**SERVICE BULLETIN**

**APPLICABILITY:** 2019-23MY Forester

**NUMBER:** 07-218-23R

**SUBJECT:** Genuine Alternative Battery Replacement

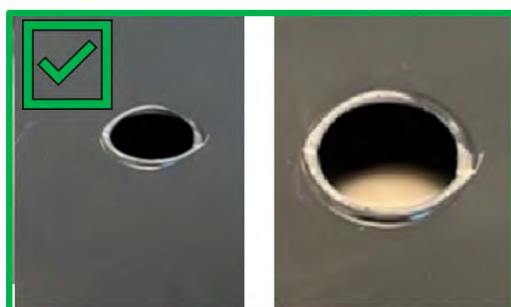
- A. CAREFULLY** cut off and trim the two protrusions on the bottom of the battery tray. This will allow a more streamlined fit when installed on the vehicle. Try to make the cut as flush as possible.

Remaining Height Is More Than 2mm

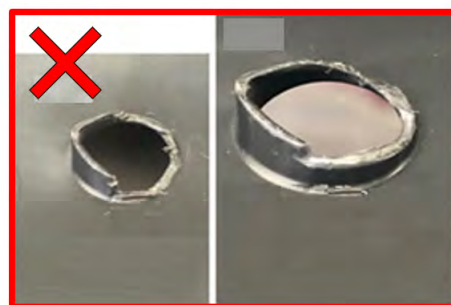
**CAUTION:** Be sure the protrusions are trimmed flush. The remaining protrusion height **MUST** be less than 2mm to provide proper fitment.

Remaining Height Is Less Than 2mm

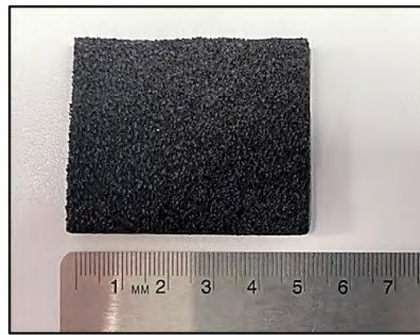
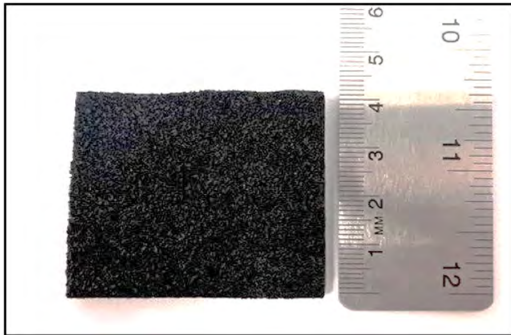
- B.** Remove the original battery tray. **DO NOT** discard, this must be returned to the customer.

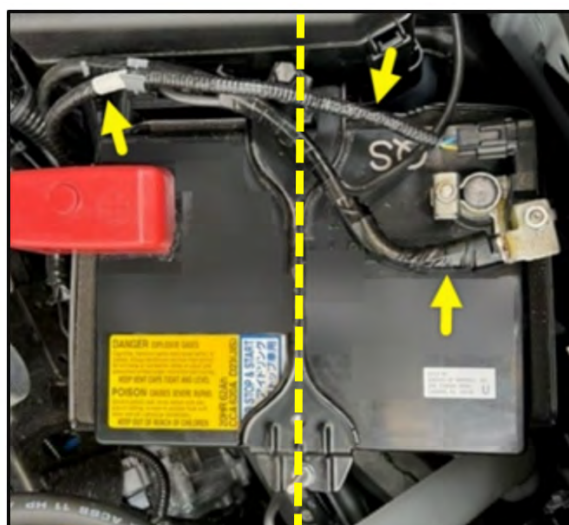
**STEP 4:** Install the NEW battery cover (p.n. 82123AN000) to the alternative replacement battery. Confirm the bottom of the cover is aligned flush with the bottom of the battery.
